**Government of the Cook Islands
INFRASTRUCTURE COOK ISLANDS**

Contract: Penrhyn Island Cyclone Centres Construction
Contract No.: CK192022

RE: NOTICE TO TENDERERS 003 – Response to Tender Queries

89x3.5SHS Connection detail

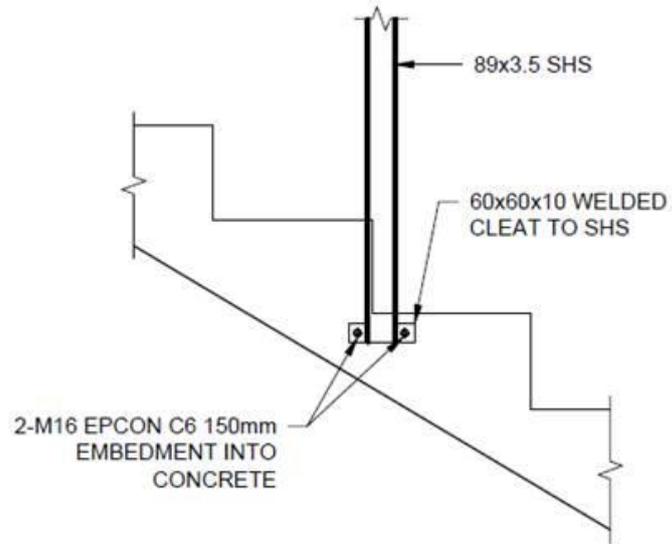
Connection detail between the bottoms of the 89x3.5SHS G350 Post (C2) with the stairs/slab is to be as per the below detail.

NOTE:
USE SAME DETAIL AT BASE/BLOCK WALL

Stair landing connection detail

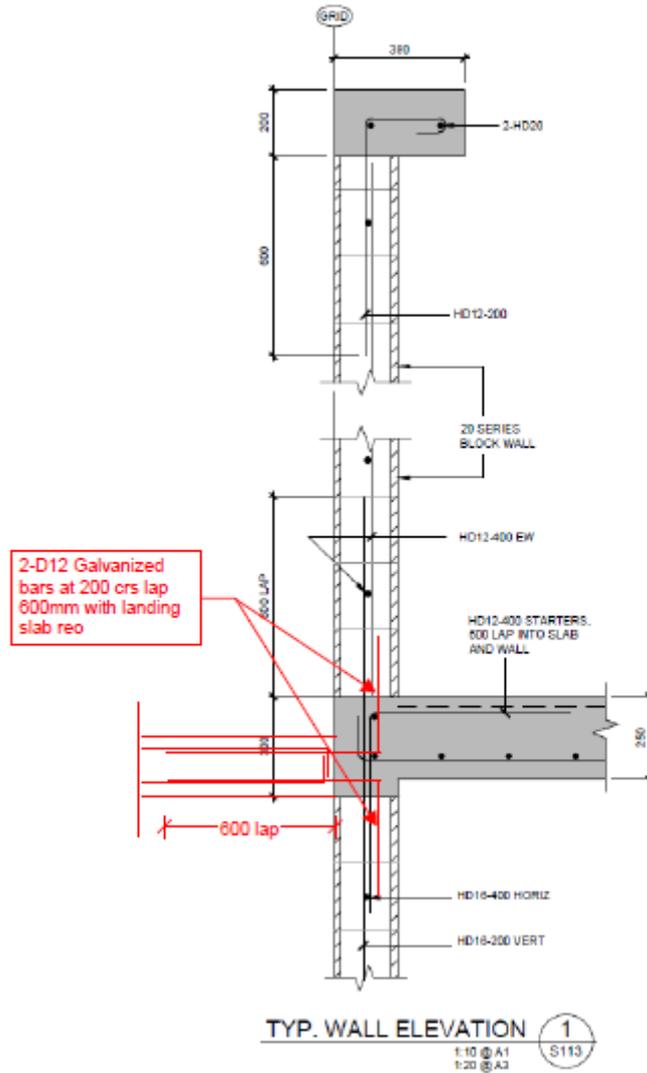
The Stair Landing to building connection detail is to be as per the below detail.
